Title: Advisory Committee on Reactor Safeguards
Digital Instrumentation and Control

Date: Friday, October 22, 2021

Revision of RG 5.71 (Draft Guidance 5061)

Cyber Security Defensive Architecture

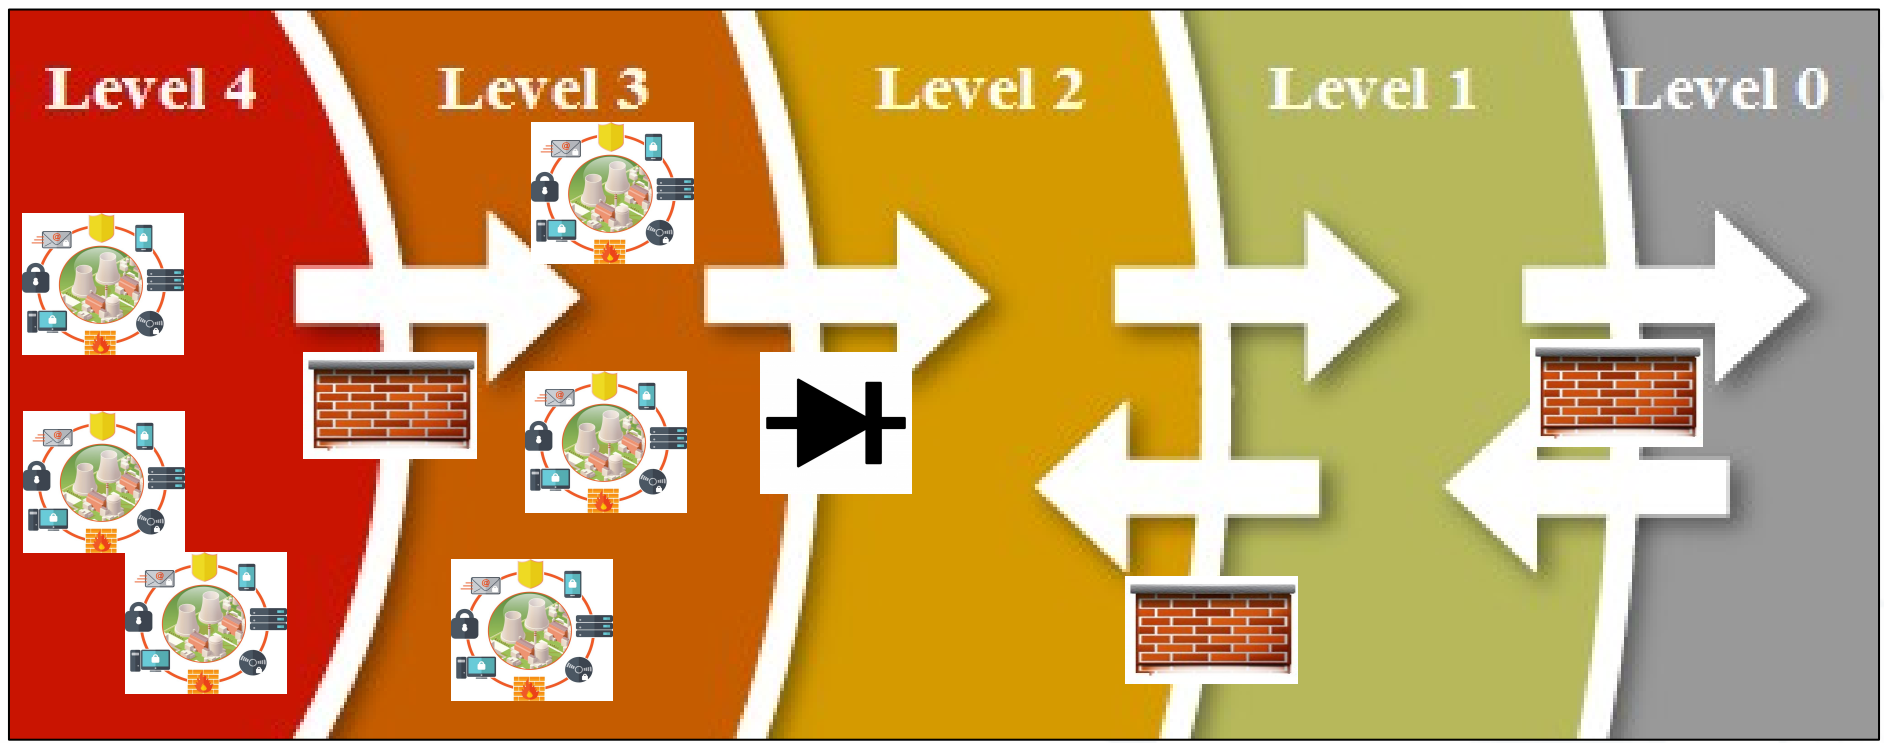
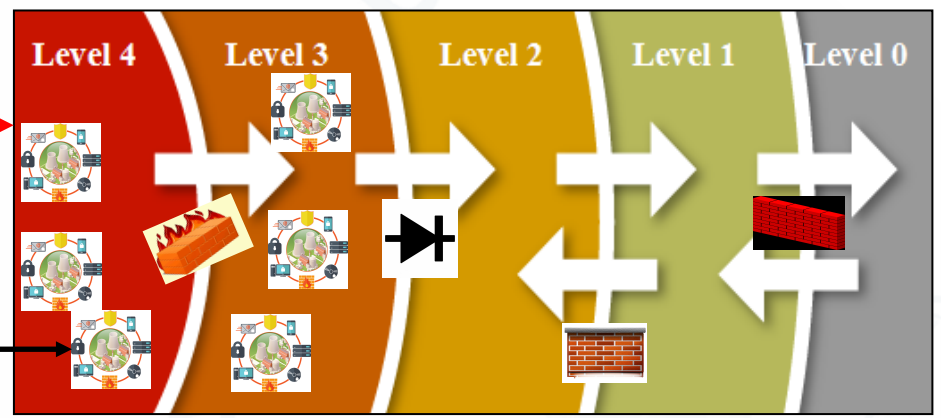
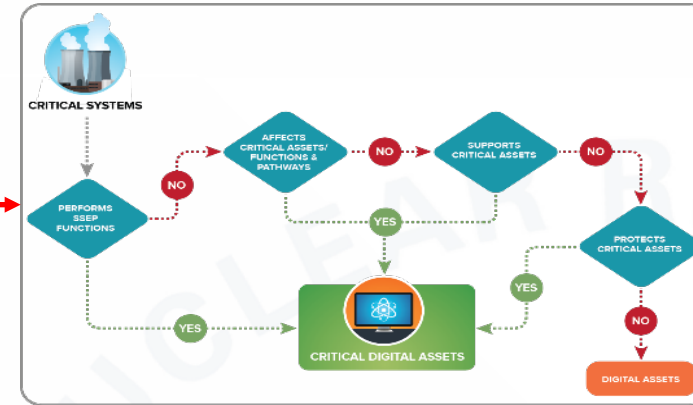
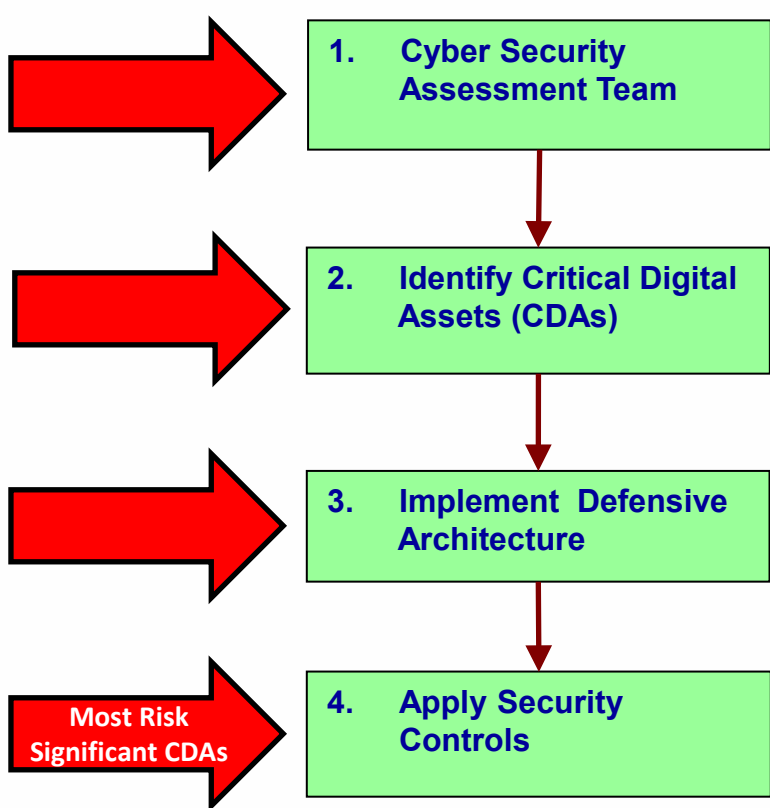
7 CHAIR BROWN: I agree with you, actually,
8 and there's an interesting change you all made to the
9 bullets underneath the defensive architecture figure.
10 I think it's now Figure 5 or 6, I don't remember
11 which, where I will bring your point that you just
12 said.

14 MEMBER KIRCHNER: I like that but then if
15 you look over from Level 4 to Level 3, that network
16 could have been a Level 3 and you show a firewall.
17 And a firewall is a bi-directional software-controlled
18 data transmission device.

11 And this was in the preamble part of 3.2,
12 the input part. One of the paragraphs talks about,
13 and it says, while a data diode can be an important
14 element of an acceptable defensive architecture, use
15 of a data diode alone does not provide adequate
16 protection to comply with the defense in-depth
17 strategies required by 73.54.

1 So, not alone but the firewall with the
2 data diode is used to provide the defense in-depth.

1 that, which is why firewalls are also used, in
2 conjunction with the correct placement of a data
3 diode. It would not be an adequate implementation to
4 have only firewalls.

Identification of Critical Digital Assets

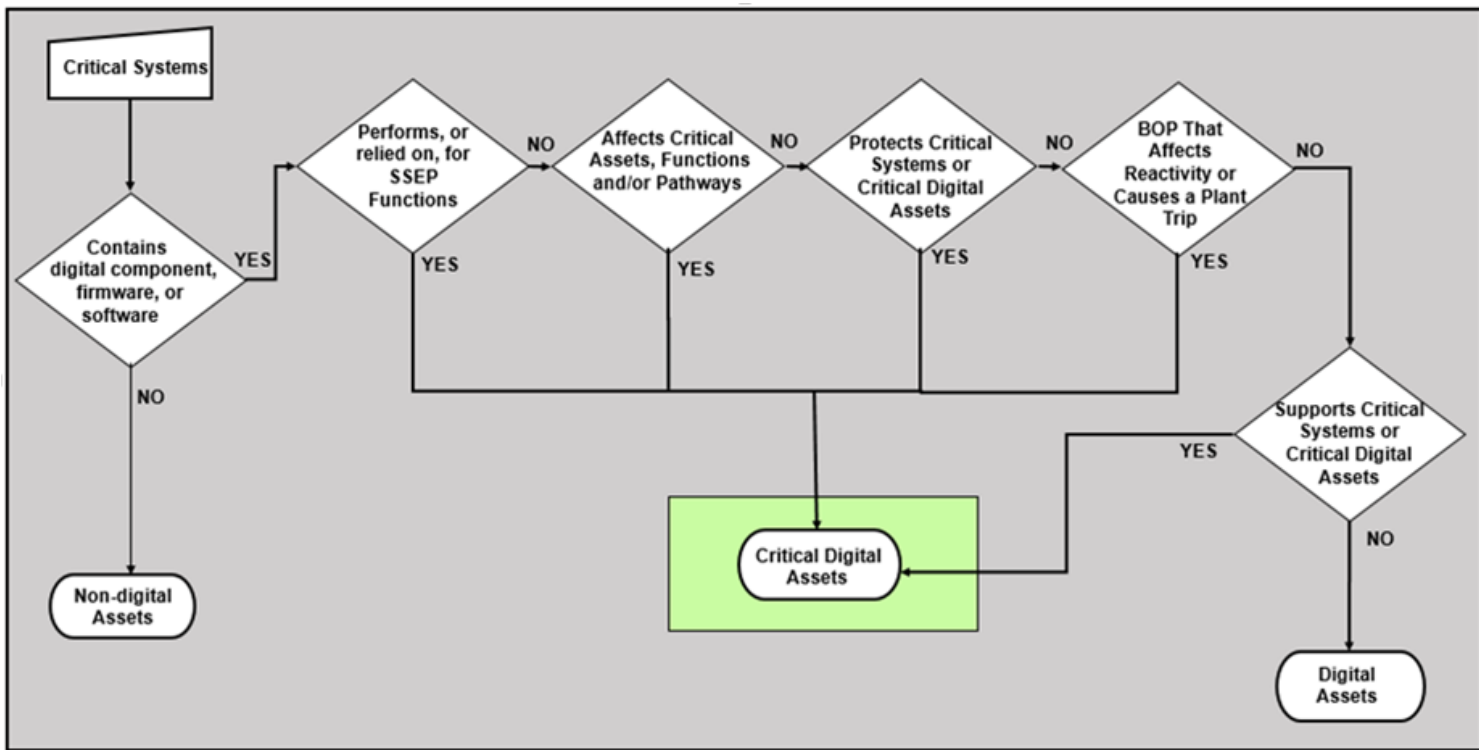
12 MEMBER KIRCHNER: Kim, this is Walt
13 Kirchner, I will go back and look at that but at a
14 very high level, how do you draw the line on defining
15 balance of plant important to safety?

16 It goes back to my comment about do you
17 use the PRA and demonstrate that you've got, I'll say
18 this, the design basis accident envelope, it covered?

19 What's the metric? In the field, how does
20 an inspector determine what's important to safety in
21 the balance of plant?

2 And it says it right there on number 6,
3 equipment that can affect reactivity or result in an
4 unplanned reactor shutdown or transient. So, it
5 should be labeled as a CDA based on that.

17 MS. LAWSON-JENKINS: I have seen very few,
18 if any, violations based on this equipment should have
19 been identified as protection for balance of plant.
20 Usually, that is pretty clear-cut.
